Project: East-West Bus Rapid Transit

Contract No.: 8716  
Enactment No.: RES-23-00028  
Dollar Amount: 65,743,246.27

**File #:** 75225      **Version:** 1      **Name:** Awarding Public Works Contract No. 8716, East - West Bus Rapid Transit.  
**Type:** Resolution      **Status:** Passed  
**File created:** 12/16/2022      **In control:** Engineering Division  
**On agenda:** 1/17/2023      **Final action:** 1/17/2023  
**Enactment date:** 1/18/2023      **Enactment #:** RES-23-00028

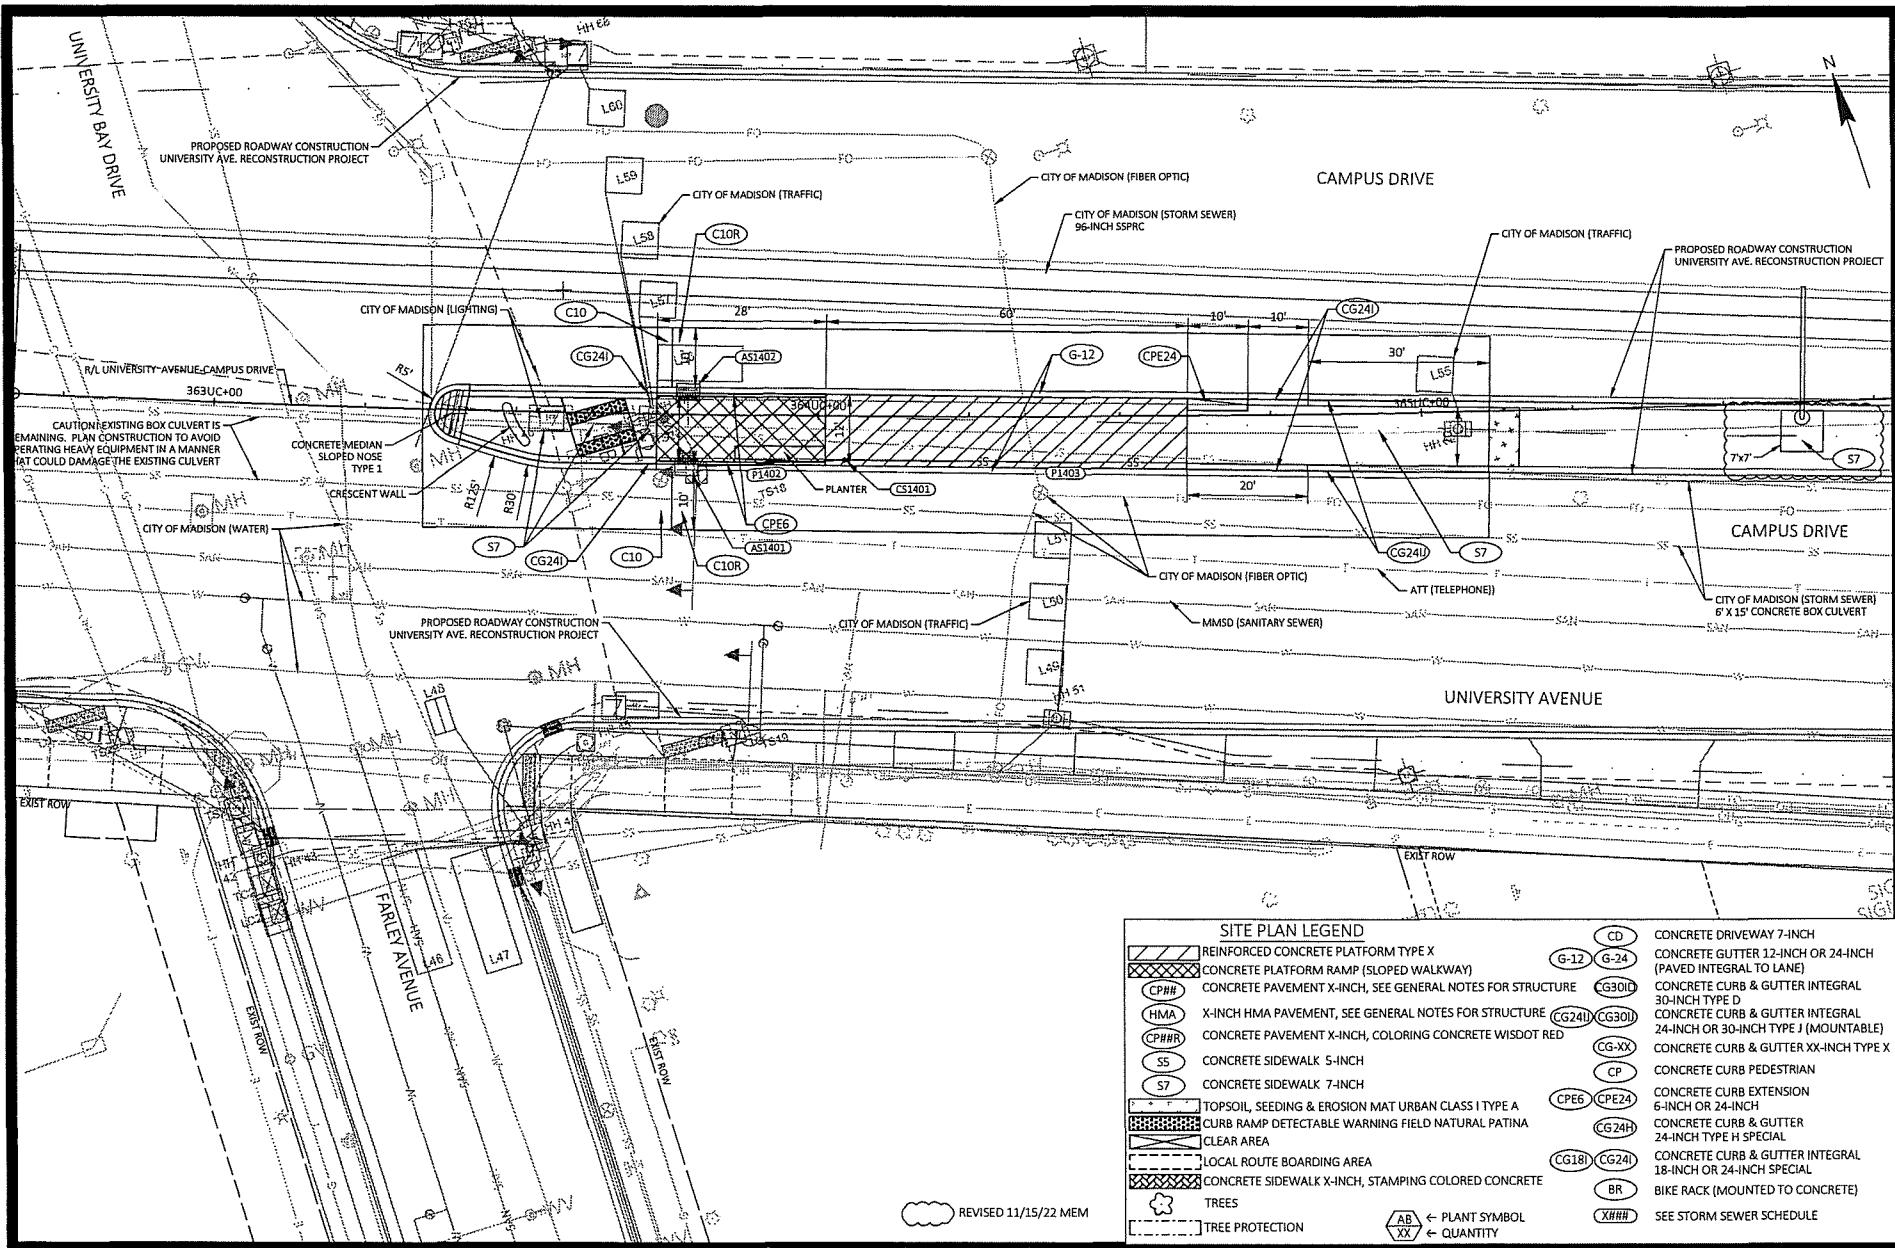
SHEET P-16W (REV 11/03/2022): Added concrete sidewalk 7-inch around overhead sign structure.

60631225P  
 G-21W

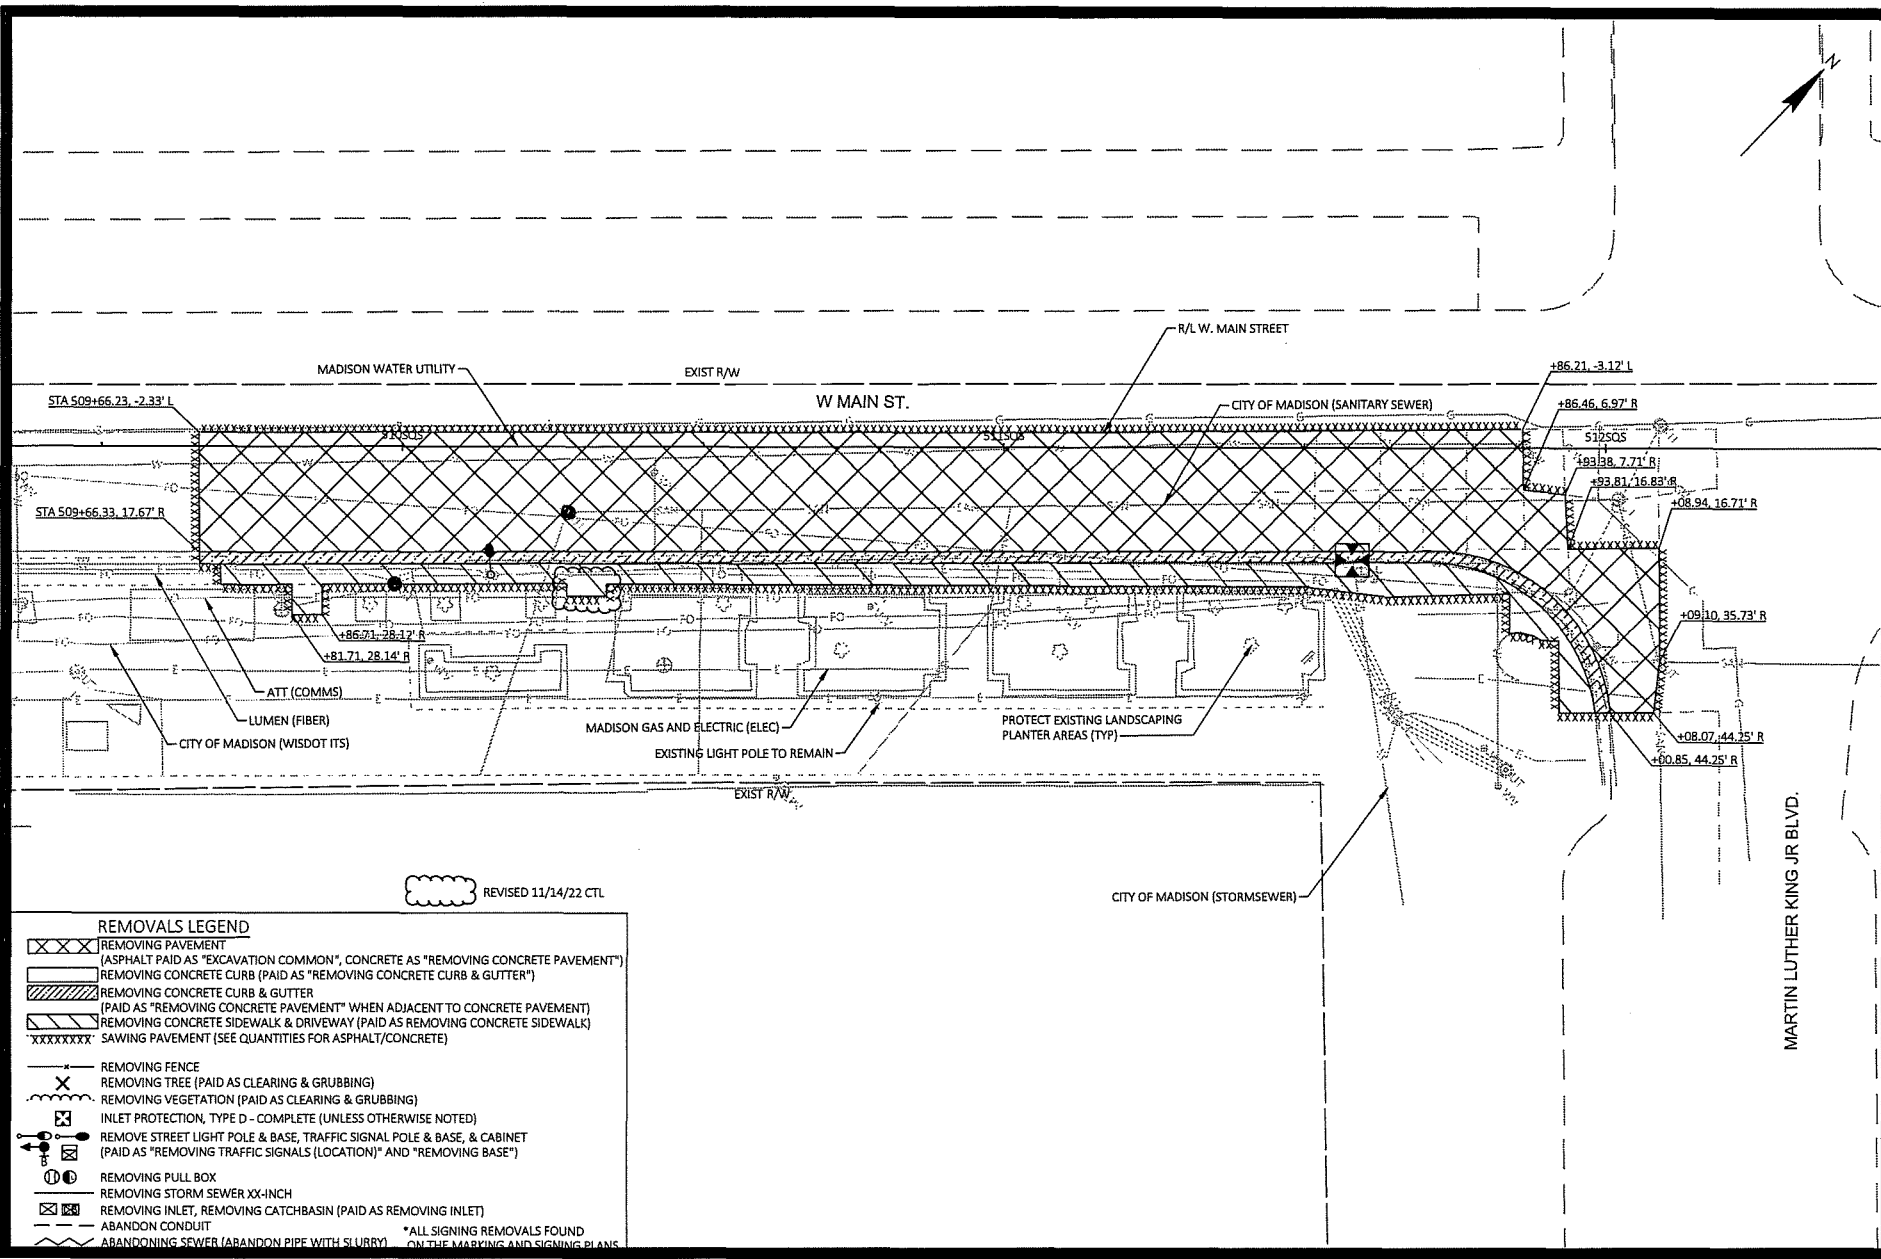
SHEET G21-W (REV 11/07/2022): Modified the grading to remove riser behind platform which eliminates the need for a handrail.

60631225P  
 P5-E

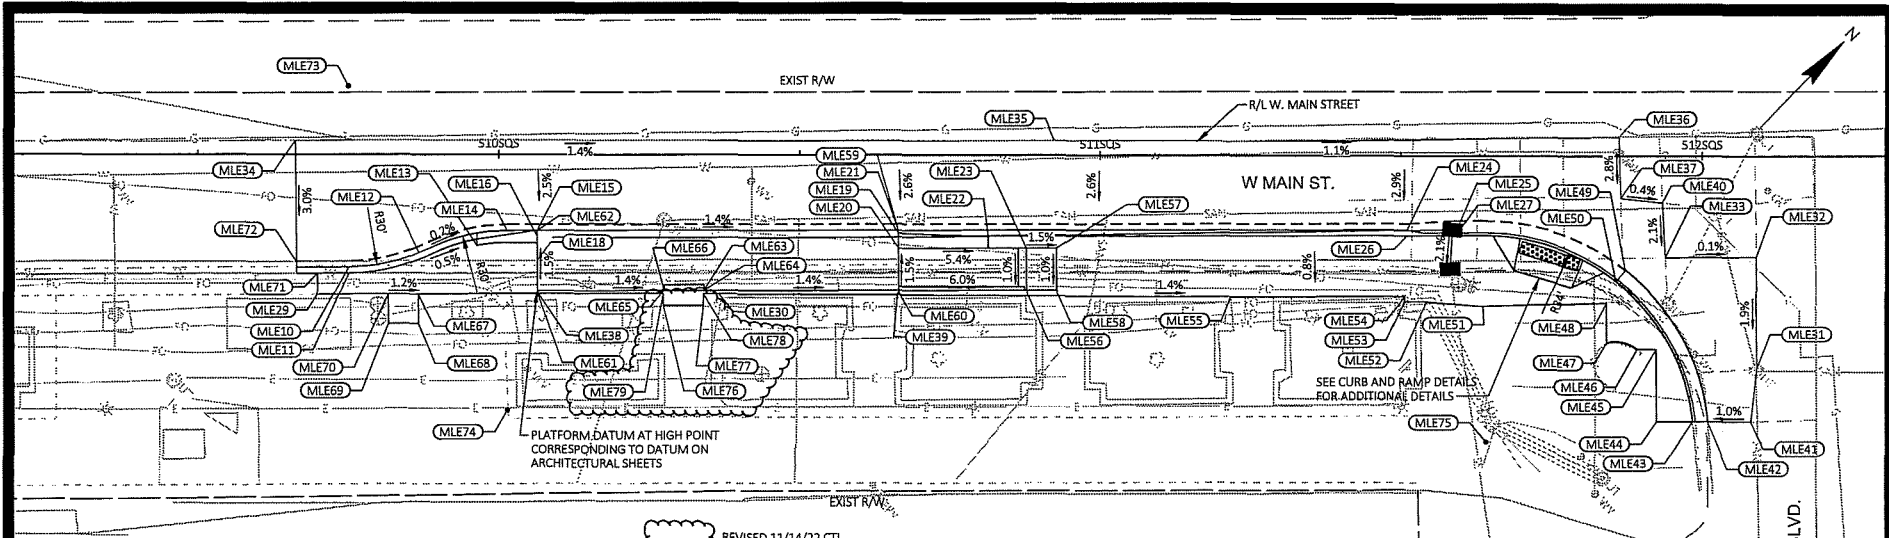
SHEET P5-E (REV 11/14/2022): Added sidewalk placement for Pedestrian Handrail placement.

60631225P  
 P12-E  
 REVISION 11/14/22 CTL

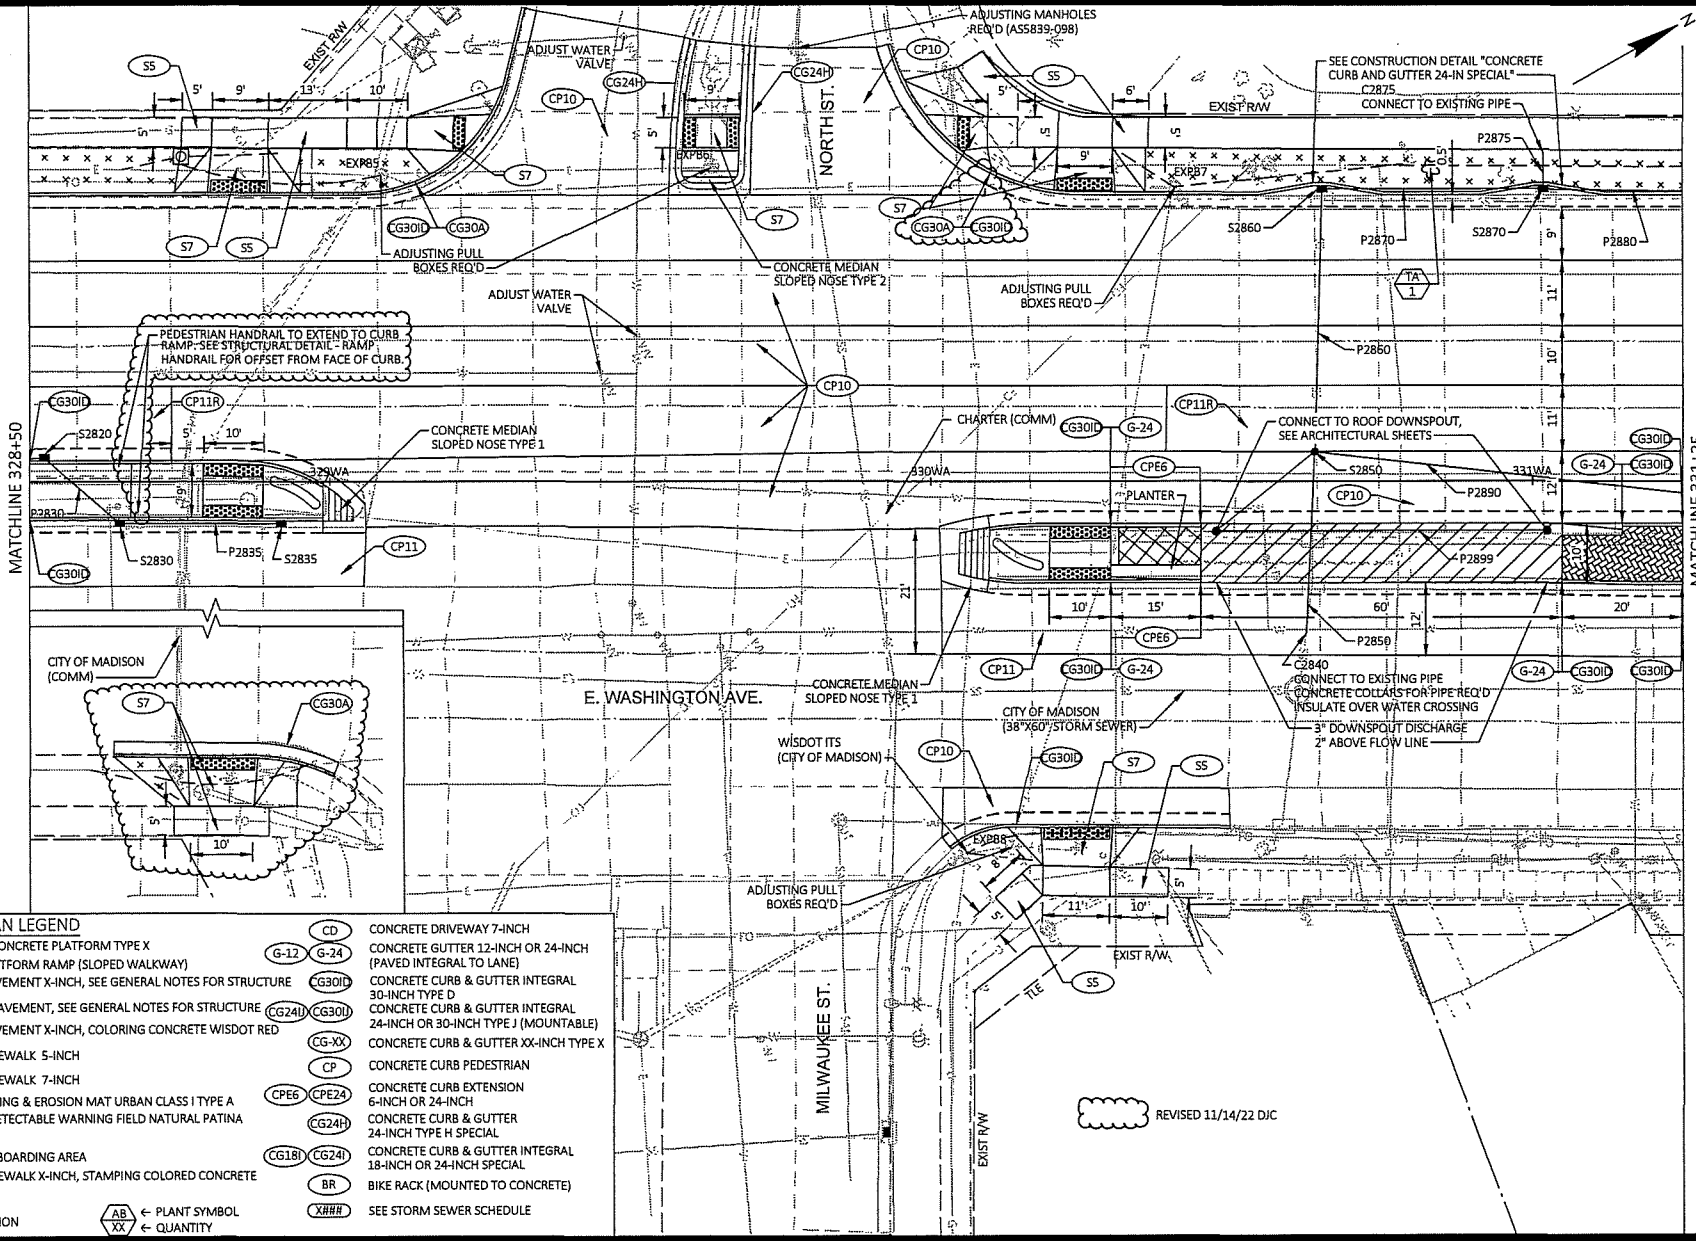
SHEET P12-E (REV 11/14/2022): Added note to clarify extended pedestrian handrail.

P20-E

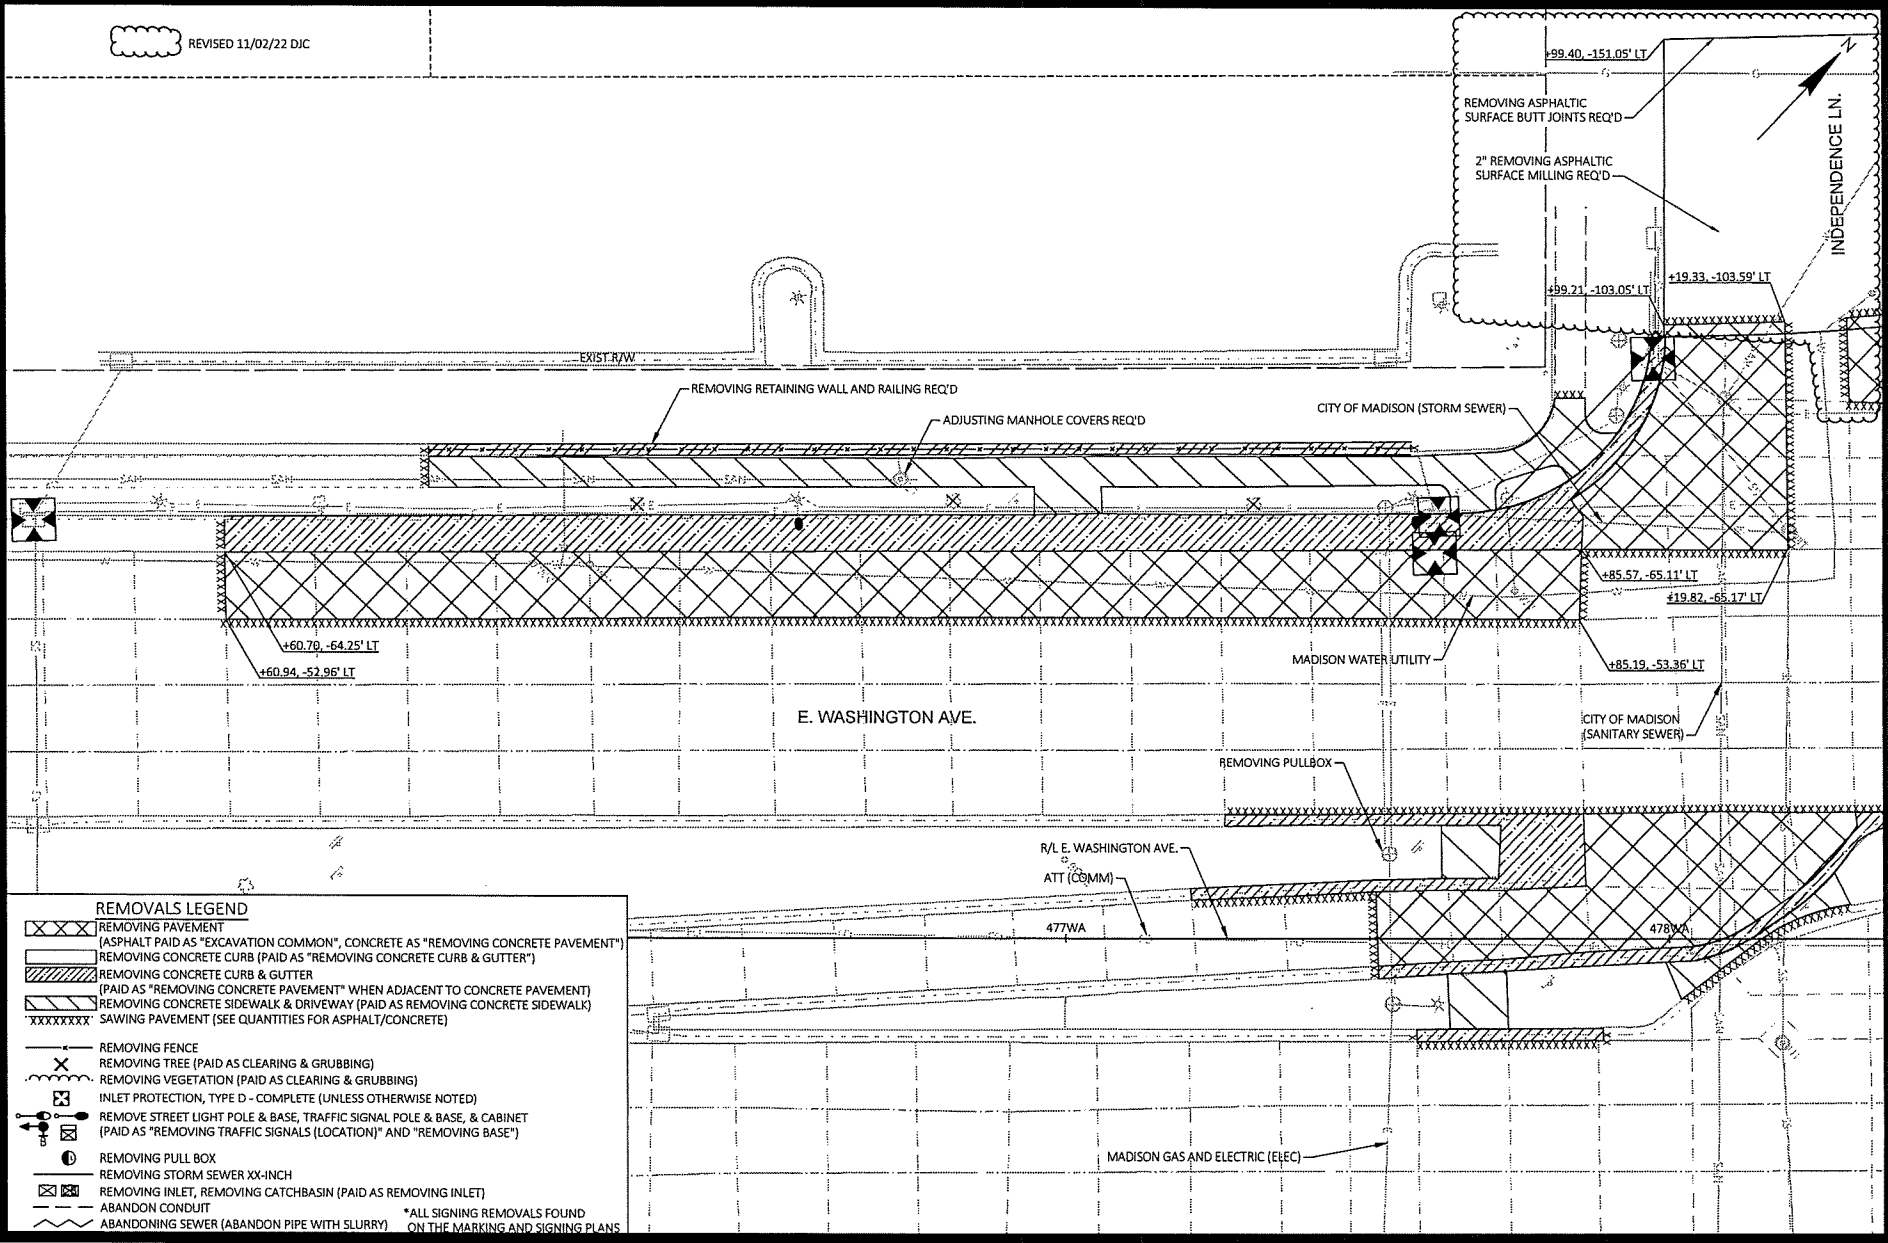
SHEET P20-E (REV 11/07/2022): Added concrete pavement label for clarity.
